U. S. NUCLEAR REGULATORY COMMISSION  
REGION IV

Report: 50-382/82-26

Facility: Waterford Steam Electric Station (WSES), Unit 3  
Taft, Louisiana

Inspection Summary

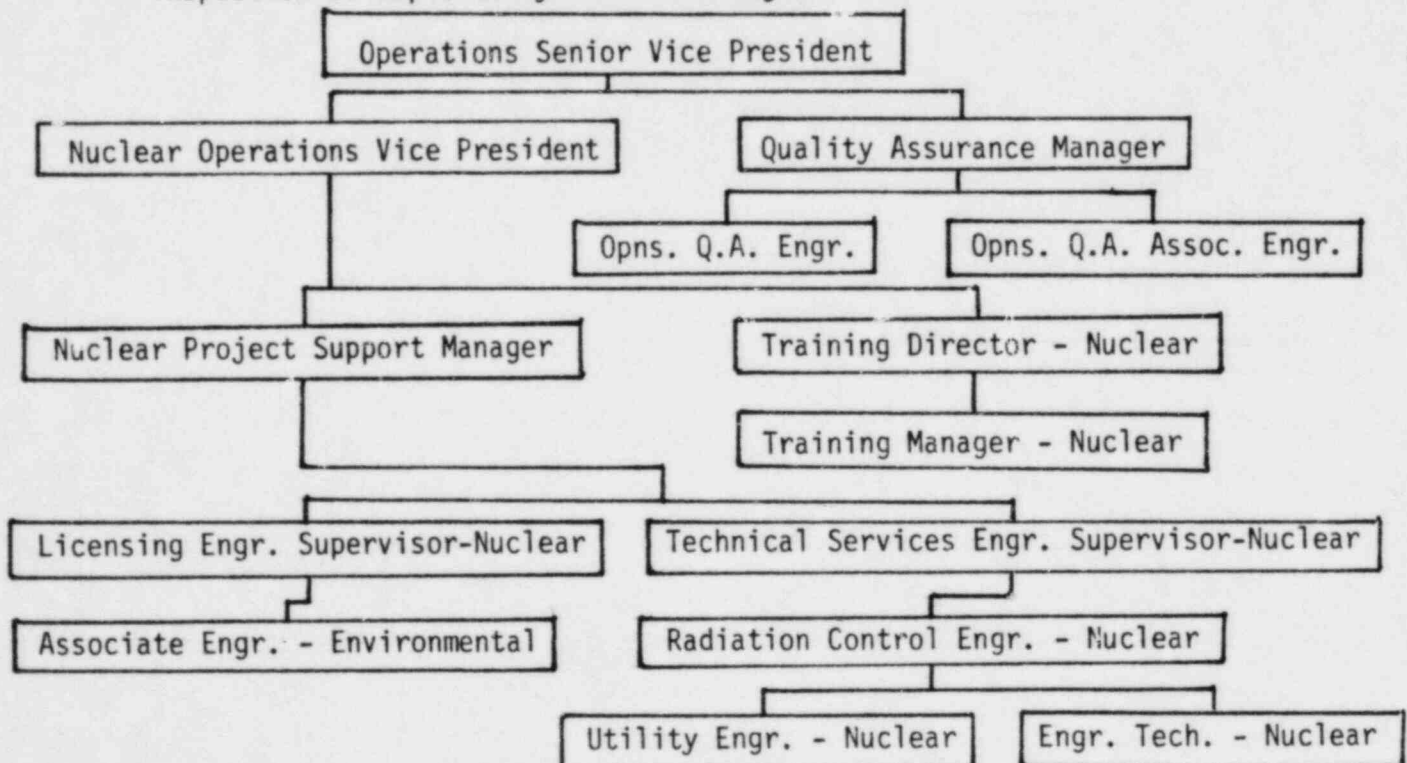
The organizational structure for the WSES preoperational environmental monitoring activities at the time of this inspection is depicted by the following chart:

The preceding chart reflects changes and shows the lines of responsibility currently associated with the preoperational environmental monitoring program.

The NRC inspector reviewed the organizational staffing plans for the operational environmental monitoring programs. The number of personnel indicated on the staffing charts appears to be sufficient to meet the staffing requirements for routine activities of the operational environmental monitoring programs. The NRC inspector noted that there are two existing vacancies for the positions of utility engineer-nuclear and engineering technician-nuclear that need to be filled to meet the staffing plans.

Discussions revealed that the individual responsible for collection, preparation, and shipment of environmental media samples during operation of WSES is a member of the WSES onsite health physics staff. The NRC inspector noted that no procedures have been established that designate the responsibilities for this individual.

- Fulfillment of the staffing plans for the operational environmental monitoring programs.

- . Establishment of procedures that designate the individual responsible for collection, preparation, and shipment of environmental media samples during operation of WSES, Unit 3.
